Re: Florence Copper Project
Draft Underground Injection Control Permit R9UIC-AZ3-FY11-1

Southwest Value Partners
Comments on
Draft Underground Injection Control Permit R9UIC-
AZ3-FY11-1
Issued to Florence Copper, Inc. for the Florence
Copper Project
Florence, Arizona

Figure F-4. LBFU in Relation to PTF Well Field¹⁴⁵

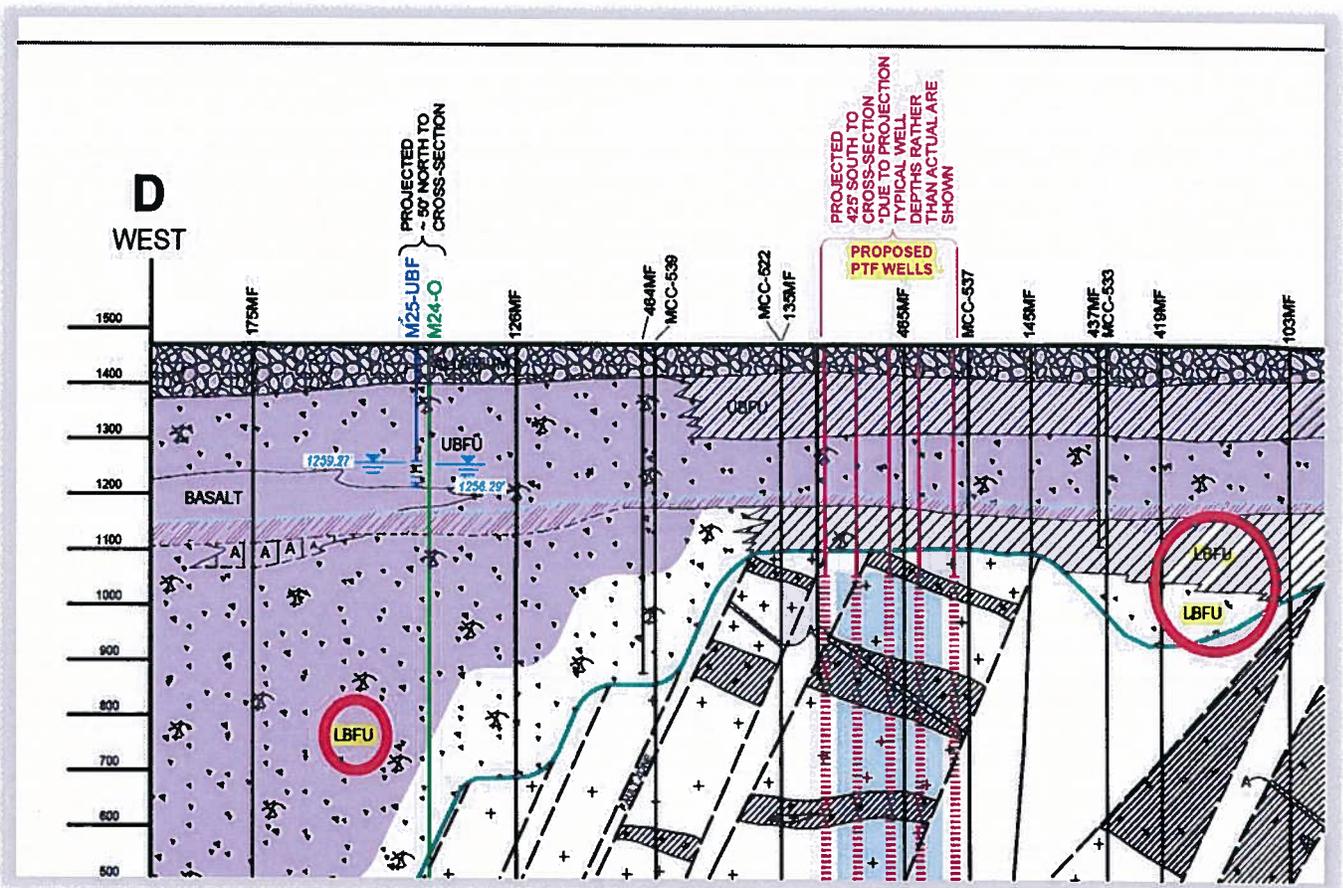
The documents purportedly relied upon by Region 9 to justify the 1997 Aquifer Exemption contain no justification for the exemption. Attachment S to FCI's application does nothing to explain how a 2.2 acre project requires a 212-acre exemption. Nor does it reference or include any documentation from the Magma-BHP Copper application to justify the exemption. The only document relied upon in FCI's application to justify the exemption is its Technical Report Pre-Feasibility Study.¹⁴⁴ But that document addresses full commercial operations, not the PTF. Therefore, no documented basis exists for the proposed aquifer exemption.

Figure I-1. BHP Tracer Test Results

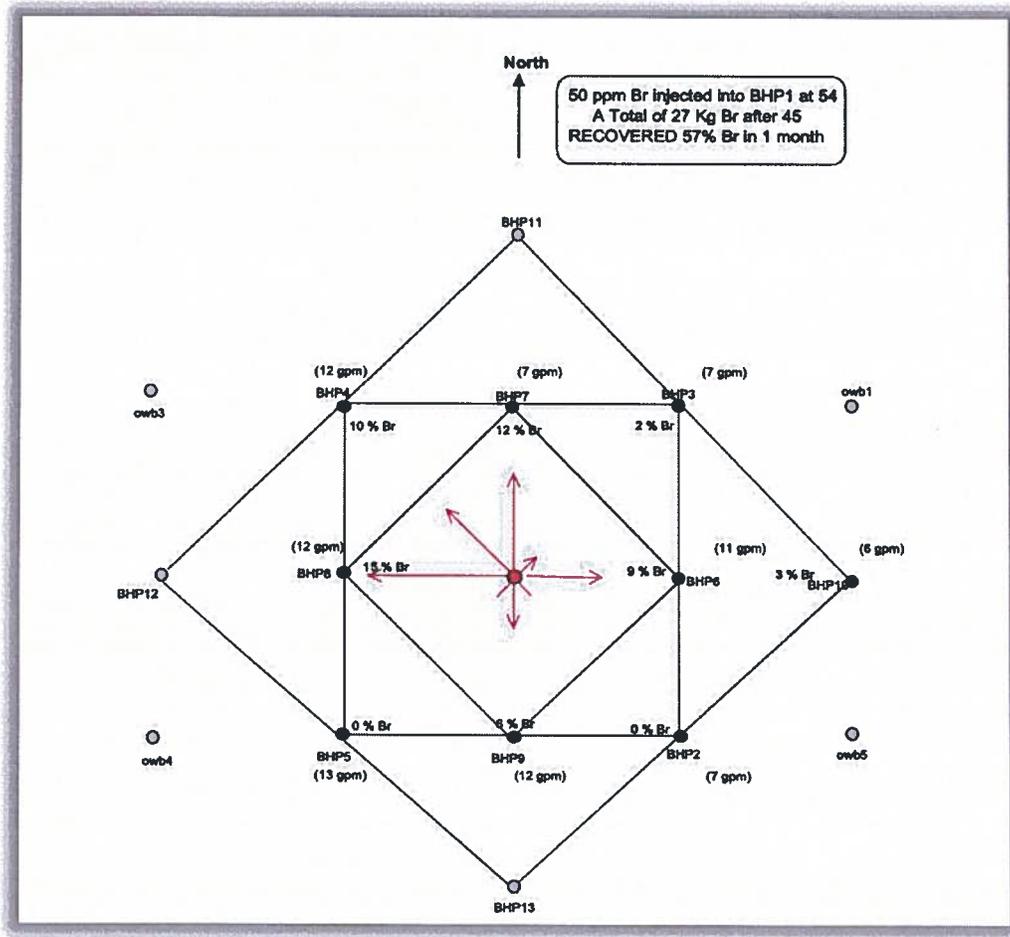
Only after conducting appropriate aquifer and tracer tests can FCI properly design and drill observation and multi-level wells. An example of the importance of this information is shown by BHP's bromide tracer tests, which demonstrated strong groundwater flows due north and due west, in addition to the northwest regional flow.¹⁸⁷ Figure I-1 below depicts the BHP tracer test results, with longer arrows showing stronger groundwater flow. Despite the near certainty of similar flows in this PTF, the draft permit does not require any observation wells in the direction of this strong groundwater flow, to the north and west of the PTF well field.

Figure I-2. BHP Water Balance Data

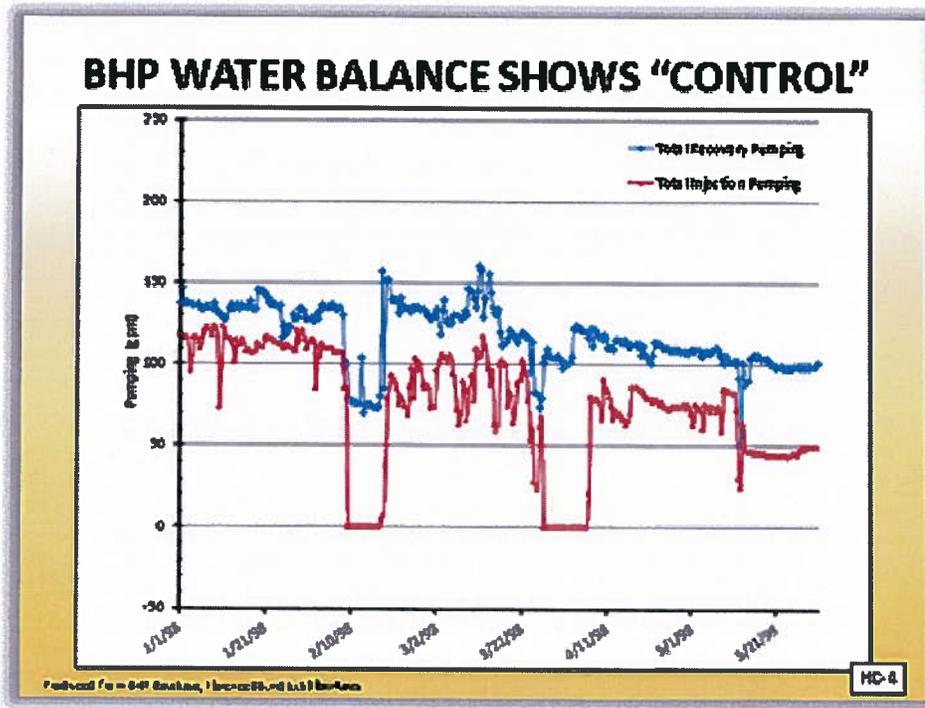
BHP's UIC permit, like this Draft Permit, required that more water be pumped out than was injected.¹⁹³ BHP appears to have fully complied with this requirement. In response to the subpoena, FCI produced a database from the BHP Pilot Test that included injection and recovery volumes during the test.¹⁹⁴ As seen in Figure I-2 below, Dr. Wilson plotted the respective volumes on a graph to visually depict BHP's compliance with the requirement to recover more fluid than was injected. In the graph, the red line depicts injected acid and the blue line shows fluid recovered. Recovery is always higher than injection, indicating that BHP complied with the water balance permit condition. Although in theory this requirement was intended to ensure that no acid escaped, we know that acid solutions did migrate beyond the recovery wells and out of the Oxide Zone. Thus, the requirement that FCI recover more fluids than it injects does nothing to prove that FCI has prevented the migration of acid mining solutions.

The problem is that volume injected is composed solely of sulfuric acid solution, whereas the liquids recovered are composed of both acid solution and native groundwater.¹⁹⁵ The draft permit's simplistic comparison of injection and recovery rates leads to an inaccurate assumption that all *sulfuric acid solution* has been recovered. For example, if FCI injects 1,000 gallons of sulfuric acid solution and recovers 1,100 gallons of combined solution and native groundwater, FCI would be deemed to have satisfied the volume differential permit condition. However, it is not true that the entire 1,000 gallons of sulfuric acid solution was recovered.¹⁹⁶ In essence, the volume differential requirement will mask the fact that FCI may be losing sulfuric acid solution. It is an apples-to-oranges comparison—acid solution in, but water and acid out.¹⁹⁷

Figure I-3. Calculation of Sulfate Balance

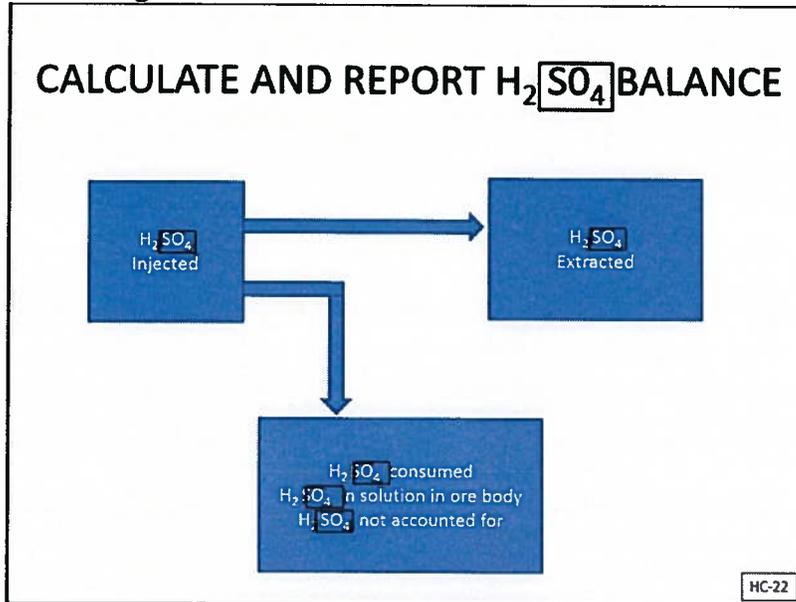
Instead, a meaningful permit must require FCI to calculate and report an acid balance or a sulfate balance.¹⁹⁹ As depicted in Figure I-3, all sulfuric acid injected in the aquifer must end up in one of four places: (1) extracted fluids; (2) consumed in chemical reactions in the oxide zone; (3) solution that remains in the ore body; or (4) fluid that has escaped the well field. By requiring FCI to calculate and report an acid or sulfate balance, EPA can determine whether FCI has properly accounted for all of the acid that it injected into the aquifer. A failure by FCI to account for all of the acid that it injected shows that FCI has not maintained hydraulic control.

Figure I-4. BHP Gradient Data

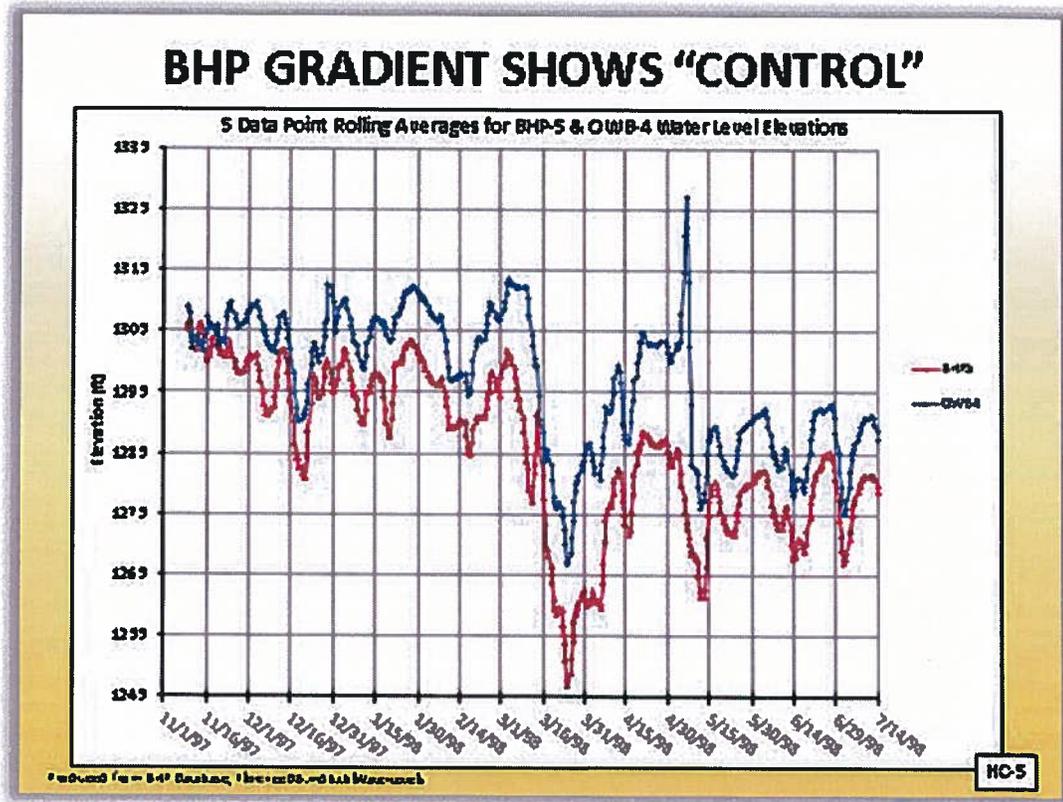
Based on BHP Pilot Test database produced by FCI, Dr. Wilson visually depicted the gradient data for BHP-9 and OWB-4, the recovery-observation well pair in the southwest corner of the BHP Pilot Test well field. In Figure I-4 below, the blue line depicts the outside, observation well water level and the red line displays the inside recovery well water level. The observation well's water level is higher than the recovery well's in all cases, indicating there was an inward hydraulic gradient. But as has already been noted, OWB-4 experienced numerous high sulfate concentrations in March and April 1998, indicating horizontal acid escape toward that observation well.

Thus, BHP complied with the water gradient permit condition in its permit during the same period when a known acid escape occurred. This demonstrates that a measured inward gradient is not enough to demonstrate hydraulic control.

Figure I-5. Well Inefficiencies in a Pumping Well

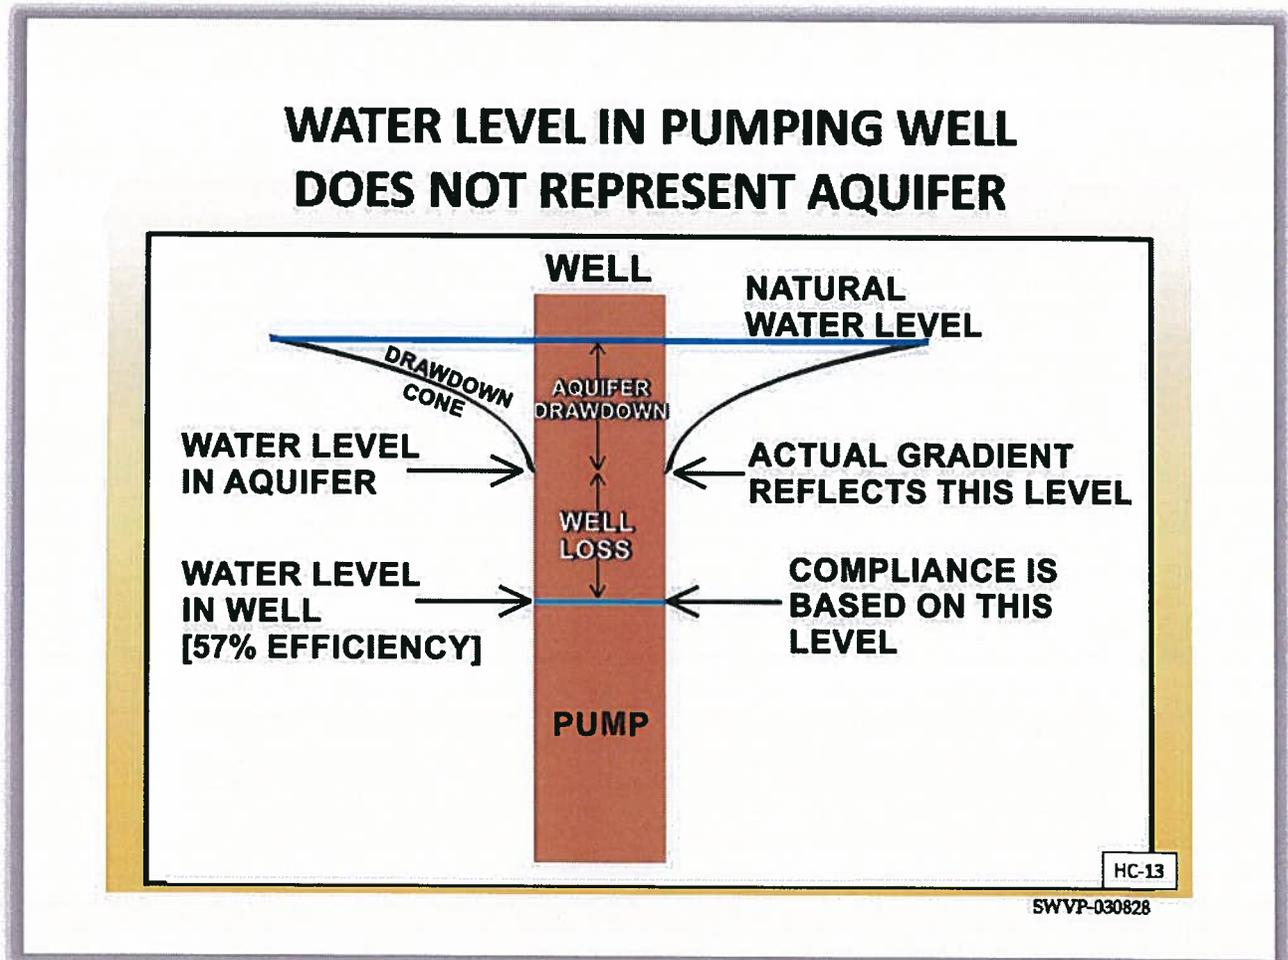
Third, the inward gradient unreasonably is based on measurement of water levels in FCI’s wells, which are affected by well inefficiencies, instead of water levels in the aquifer. As depicted in Figure I-5 below, well inefficiency occurs because water levels are lower inside a pumping well than the water levels of the actual groundwater aquifer that it is intended to reflect.²²¹ As reflected in Figure I-6 below, this issue is well understood by EPA and should have been incorporated into the permit requirements.²²²

efficiency.²²⁴ Jeff Bryan admitted that errors in water levels could be greater than the minimum one-foot differential, which would lead to a false conclusion that FCI had maintained an inward gradient.²²⁵ Consequently, the one-foot inward gradient permit condition can be met by well inefficiency alone, not the actual groundwater aquifer level, and is therefore unreasonable.²²⁶

Figure K-1. Arsenic Rebound in BHP Test Wells

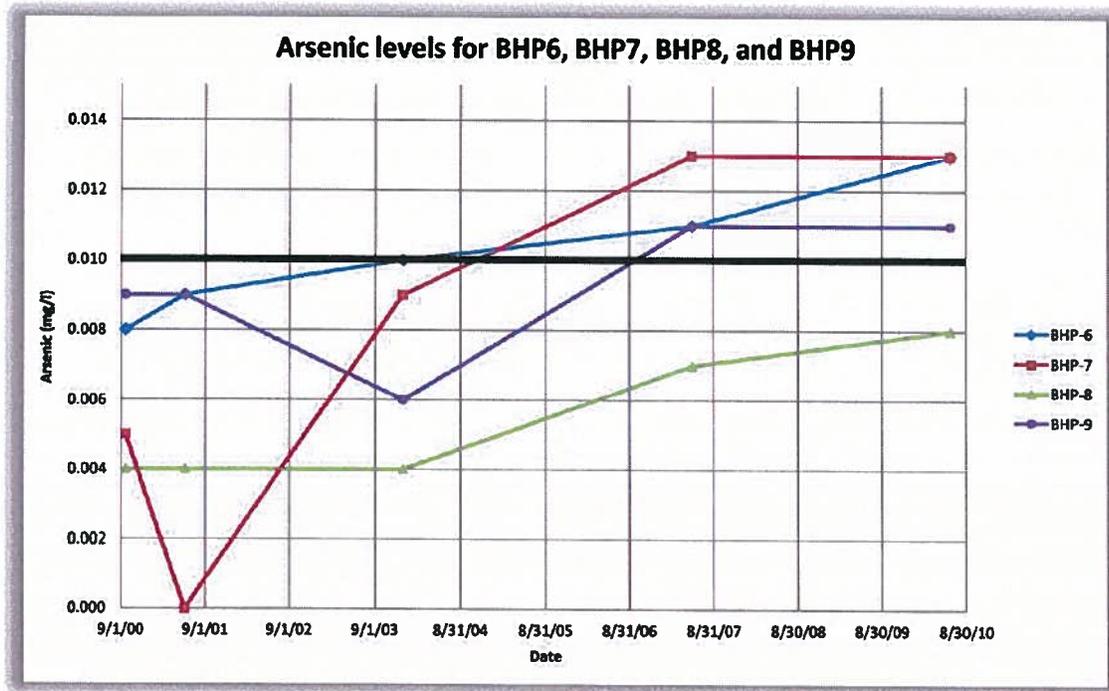
EPA Region 9 should require FCI to publically explain why the geochemical model submitted with FCI’s application predicts arsenic concentrations significantly lower than the results testified to by Dr. McNulty and the arsenic standard sought by FCI for the state permit.
